Public Comment on EPA Draft Permit PAS2D701BALL

On 06/22/2017, EPA published a Public Notice of intent¹ to issue Permit # PAS2D701BALL (“Permit”)² to Penneco, LLC, for conversion of the well Sedat 3A, API Number 003-21223, (“Well”) to an injection well for disposal of Oil & Gas wastewater, as supported by a Statement of Basis (“Basis”)³. I object to the issuance of this permit, and in response to EPA’s request for public comment, wish to make the following public comments.

Figure 1: Bradford-Broadtop Lineament

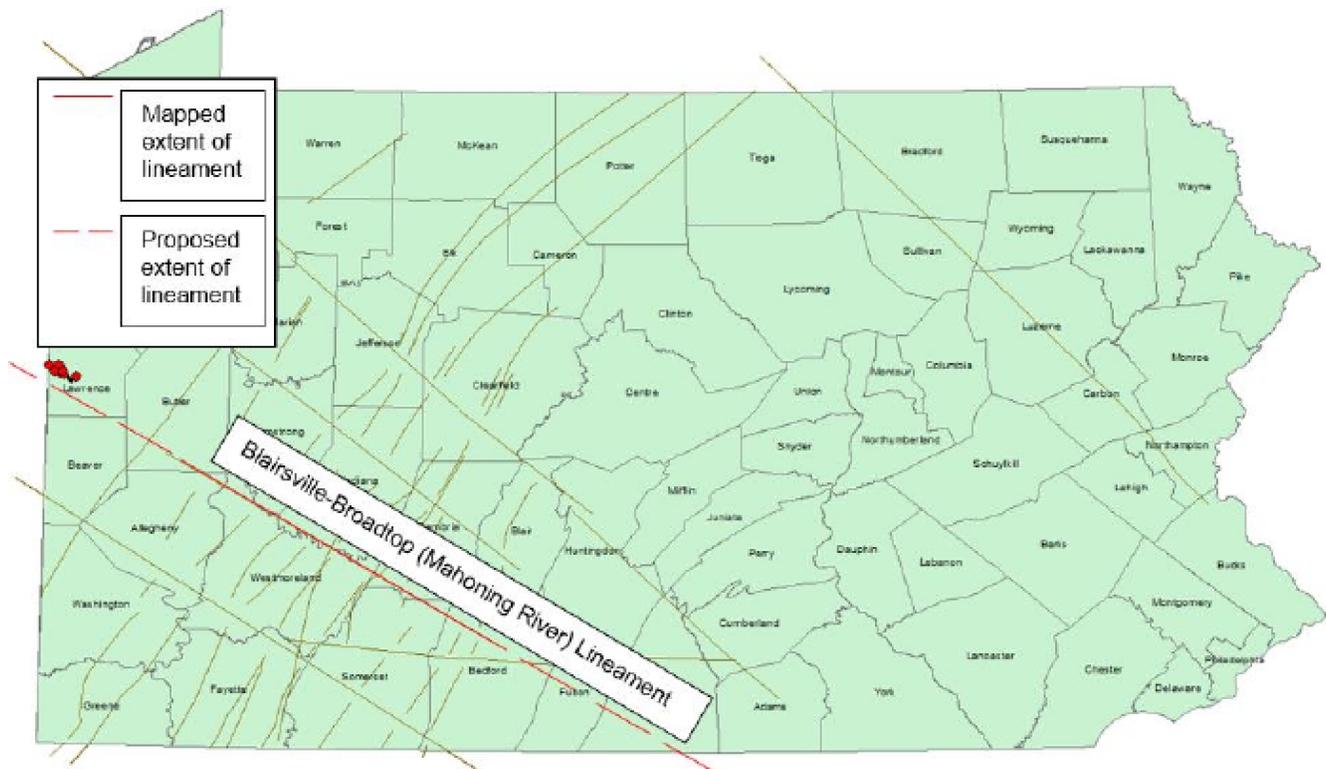
Figure 1 is a reproduction of Figure 4 from Lawrence Review, showing a feature known as the Blairsville-Broadtop Lineament (also known as the Mahoning River Lineament). This feature has been associated with both the Lawrence County event on April 25 2016 and earthquakes in Ohio (see e.g. Lawrence Review, “Preliminary Report on Earthquakes in Youngstown Caused by an Injection Well” Ohio Department of Natural Resources, March 12, 2012¹⁶). The location of Sedat 3A is disturbingly close to the Blairsville-Broadtop Lineament (though not as close as the wells associated with the Lawrence County event. Basis shows no analysis of this association, and its implications for the risk of earthquakes from an injection well constructed from the existing well Sedat 3A. This clearly shows EPA’s analysis of earthquake risk in Basis is incomplete and inadequate.

DEP Mine Subsidence Insurance Risk Map for the Vicinity of Sedat 3A

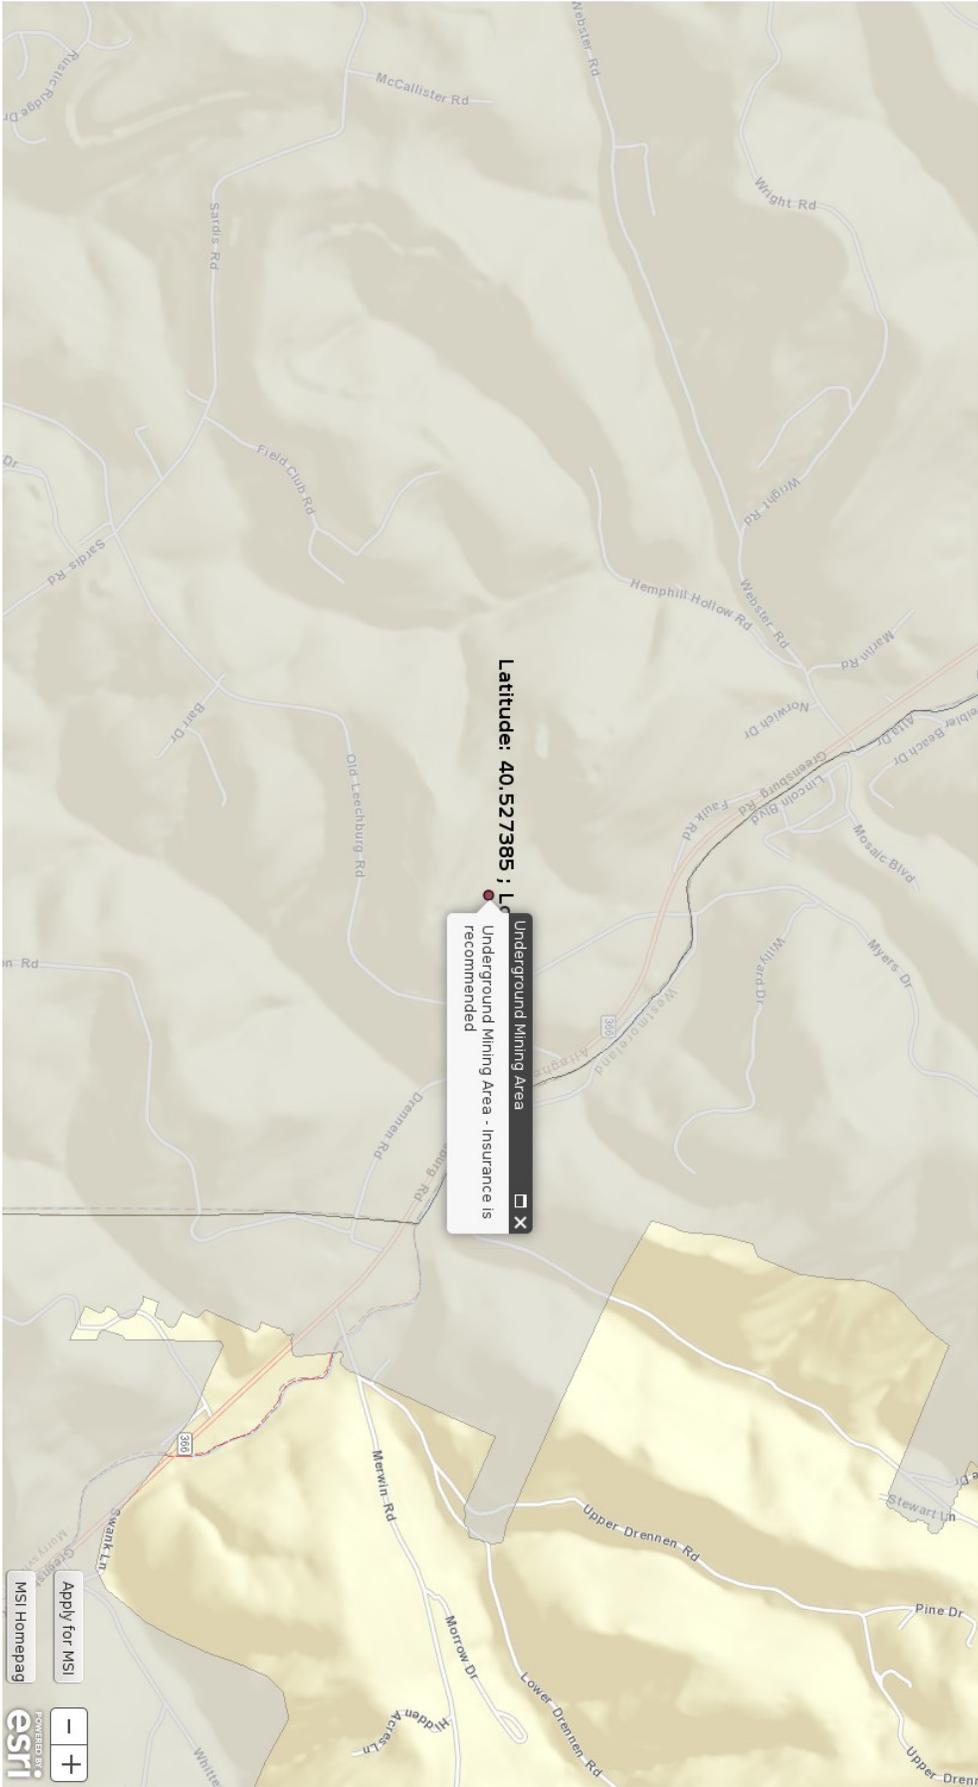
Appendix 2 shows a map of the Mine Subsidence Insurance risk for the area around Sedat 3A¹⁸. The location of Sedat 3A is clearly notated as “Underground Mining Area – Insurance is recommended”. However, Basis is completely silent on this subject. This is simply inexcusable! What would the implications be for an injection well if mine subsidence occurred? What are the implications for Confining Zones? It is nothing less than outrageous that this has not been analyzed. If there is any tangible risk whatever of mine subsidence, this should in and of itself *completely disqualify* this location from hosting an injection well. EPA should deny outright any application for a UIC disposal well in any Mine Subsidence Insurance risk area.
